Model 100
Parts Bulletin P1

VA 8518A FUEL RETURN CHECK VALVE REPLACEMENT

Model 100 Fuel Injection Pumps on International Harvester Engines

FIGURE 1.

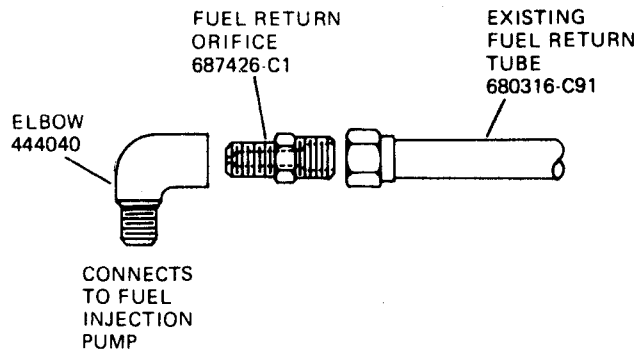
Fuel return check valve VA 8518A has been discontinued as a service replacement.

When a VA 8518A requires replacement, the fuel return circuit should be updated in accordance with I.H. service bulletins for specific engine installations: Agricultural Equipment Bulletin No. S-3624, Truck Service Bulletin SLF-78-13 and Construction Equipment (Pay Line) No. 12H-78-02.

FIGURE 1.

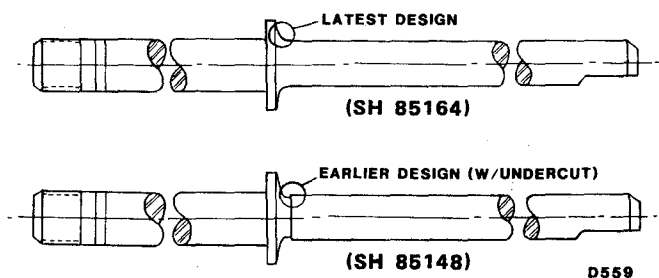
The undercut in the Model 100 governor weight shaft has been eliminated. Latest shafts are now machined with a radius blend in that area. See Figure 1.

FIGURE 3.

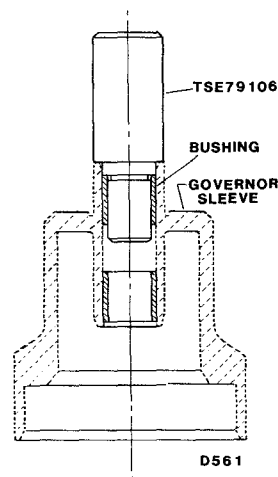
Pressing tool, TSE 79106 can be used to correctly reposition the bushing in governor sleeve, SV 8522A. See Figure 3.

Use TSE 79106 to correctly position the bushing and to maintain concentricity.

FIGURE 2.

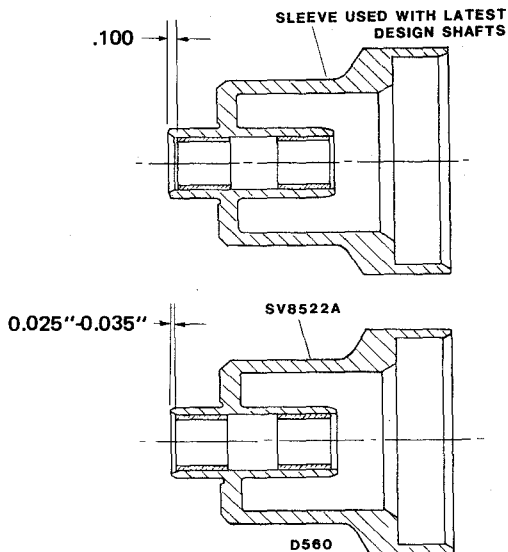
Because of this change in design, the governor sleeve used with the new shaft **must** have a bushing recessed to a greater depth than present SV 8522A requirement. Refer to Figure 2.

When a new governor weight shaft, SH 85164 (or a weight and shaft assembly which contains this shaft) is installed in a M-100 pump, check the governor sleeve and reposition the bushing to .100" (2.54 mm) dimension if it is not at that depth. Information form (IF8536) will be packaged with appropriate shafts and assemblies indicating the need of the new (or modified) sleeve.

When a governor sleeve is being replaced and it is uncertain which governor weight shaft the pump contains, make certain governor sleeve bushing is recessed .100" (2.54 mm).

FIGURE 1.

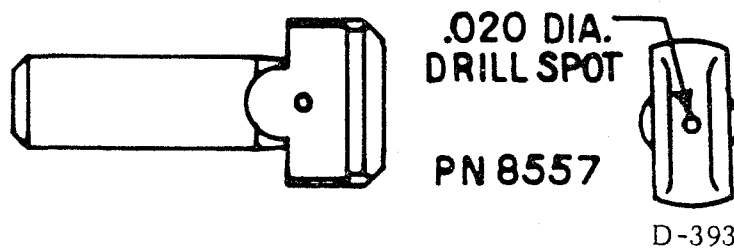
- Late production fuel injection pumps (1006A100A9398-1 and 9399-1) supplied to British Leyland contained plunger sleeve pin, PN 8557. The same pin was also contained in 1006A100A9378C1 and 9379C1 pumps.
- PN 8557 is the replacement for PN 8525 in Model 100 pumps applied to British Leyland engines **only**.
- Control unit assembly, CU 8522-1A, is equipped with PN 8557.
- Late production PN 8557 pins are identified by a drill spot (hole) in the pin face (See fig. 1). Early production PN 8557 pins did not have any identification and their appearance was the same as PN 8525.

IMPORTANT: Select a pin that will provide a .001" maximum clearance between the pin shaft and control unit bore. Dip the pin in clean calibrating oil and insert the shaft into the control unit bore. If the clearance is correct, a suction fit will result.

- (1) Replace PN 8525 pins with late production PH 8557 pins in all British Leyland pumps received for repair.
- (2) Stamp an "M" suffix behind the British Leyland part number on the nameplate when a PN 8557 or CU 8522-1A is installed in a pump - (Example: AAU 6953M). This will provide a means for identifying pumps that have been updated.

NOTE: "A" is the angle between center of pin and timing mark.

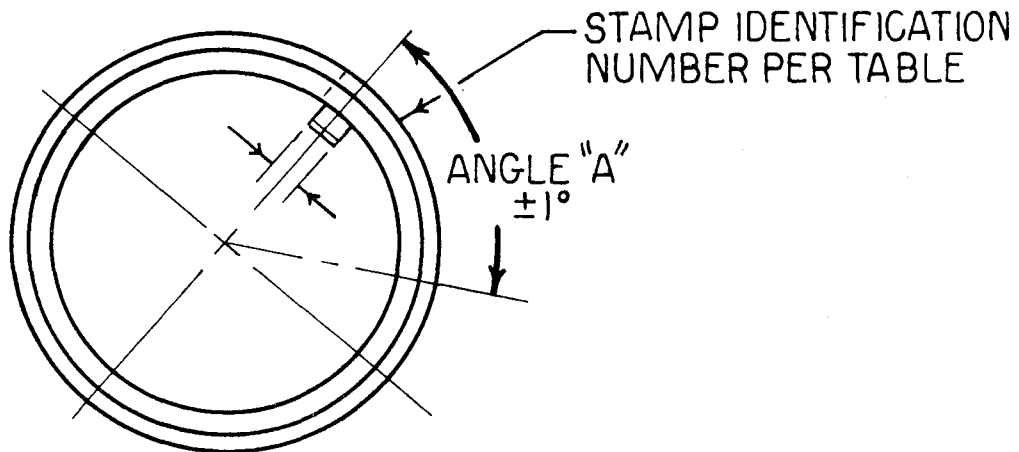
The following chart is an aid for customers to identify which face gear will accompany a particular pump application when the pump is equipped with a 2-piece face

gear/hub. Face gears must not be interchanged when replaced.

EXAMPLE: GE 8527-1 cannot be replaced by GE 8527-5.

*On GE 8527-4 only, a yellow stripe of dykem will extend over the full length of timing mark.
